REMARKS

This communication is a full and timely response to the final Office Action dated June 19, 2008. Claims 1-15 remain pending, where claims 7-9 are withdrawn. By this communication, claims 1-15 are amended. Support for the amended subject matter can be found, for example, at page 8, lines 11-23, page 9, lines 21-26 and Figs.2 and 3 of the Applicant's disclosure.

Fig.1.

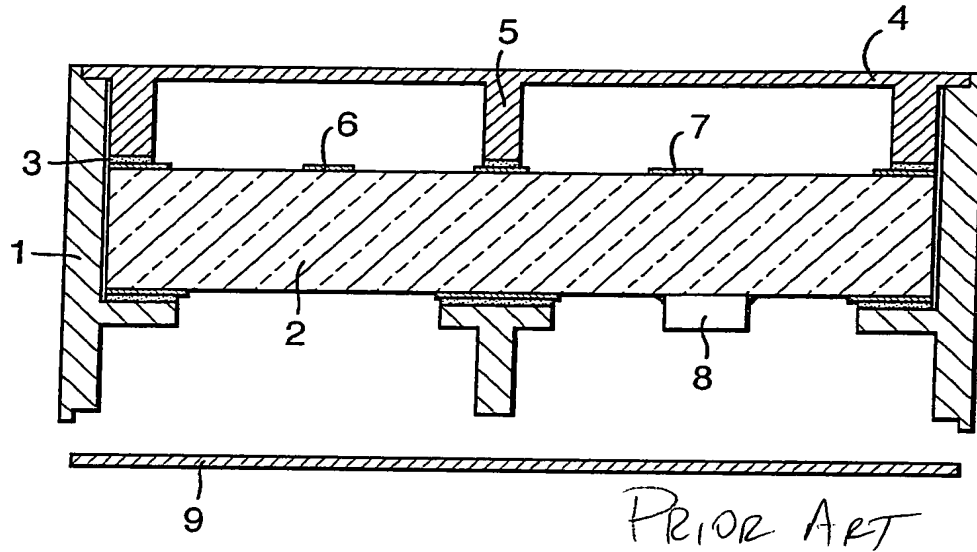
In numbered paragraph 4 on page 3 of the Office Action, Figure 1 is objected to for allegedly failing to include a "Prior Art" legend. Applicant appreciates the Examiner's diligence and has amended Figure 1 to include the "Prior Art" legend. Withdrawal is respectfully requested.

First, as shown in Applicants' Fig. 1, *APA* does not include one or more elongate stub walls. The Examiner alleges that the conductive tracks 6, 7 provided in the drawing are analogous to Applicant's claimed elongate stub walls. See Office Action, pg 6. One of ordinary skill would understand, however, that the conductive tracks 6, 7 cannot function as elongate stub walls. The conductive tracks 6, 7 are deposited on the planar surface of the substrate after the surfaces have been ground ("processed"). To do so before would destroy the operability of these components, and arguably remove the conductive tracks from the surface of the substrate. As discussed on page 4, lines 12-23 of Applicant's disclosure, surface planarization of the substrate is necessary prior to RF component fabrication. Applicant respectfully submits that "RF component fabrication" includes the laying of conductive tracks 6, 7 on the planar surface of the substrate. Thus, the Examiner's interpretation of the conductive tracks 6,7 as Applicant's claimed elongate stub walls is inconsistent with Applicants' disclosure and the application of conductive tracks 6, 7 as understood by one of ordinary skill.

The attached drawing sheet includes changes to Figure 1 and replaces the original sheet including Figures 1-3. Specifically, the legend "PRIOR ART" has been added to Figure 1.

Fig.2.

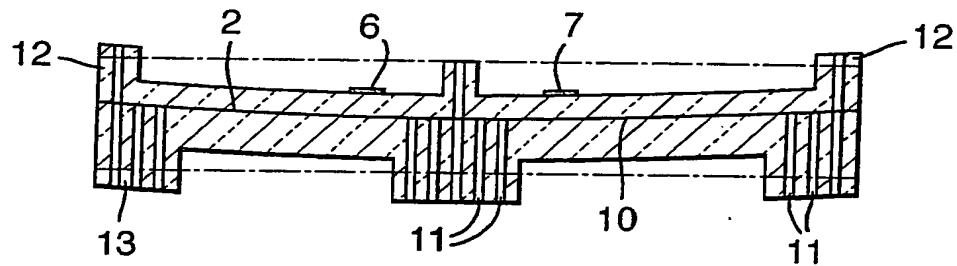
As exemplified in Figures 2 and 3, Applicant discloses a circuit having a ceramic substrate 2. Conductive RF signal tracks 6 and 7 formed in a first conductive layer of the substrate 2. A ground plane 10 formed in a second conductive layer of the substrate. Stub walls 12 are formed in an outer ring track and an inner wall track of the substrate 2. Vias 11 extend from the RF ground plane 10 to upper surfaces of the stub walls 12. Further stub walls 13 are formed on the lower surface of the substrate with additional vias extending between ground plane 10. See U.S. Patent Application Pub. No. 2007-0139143, pgphs [0027] - [0028].
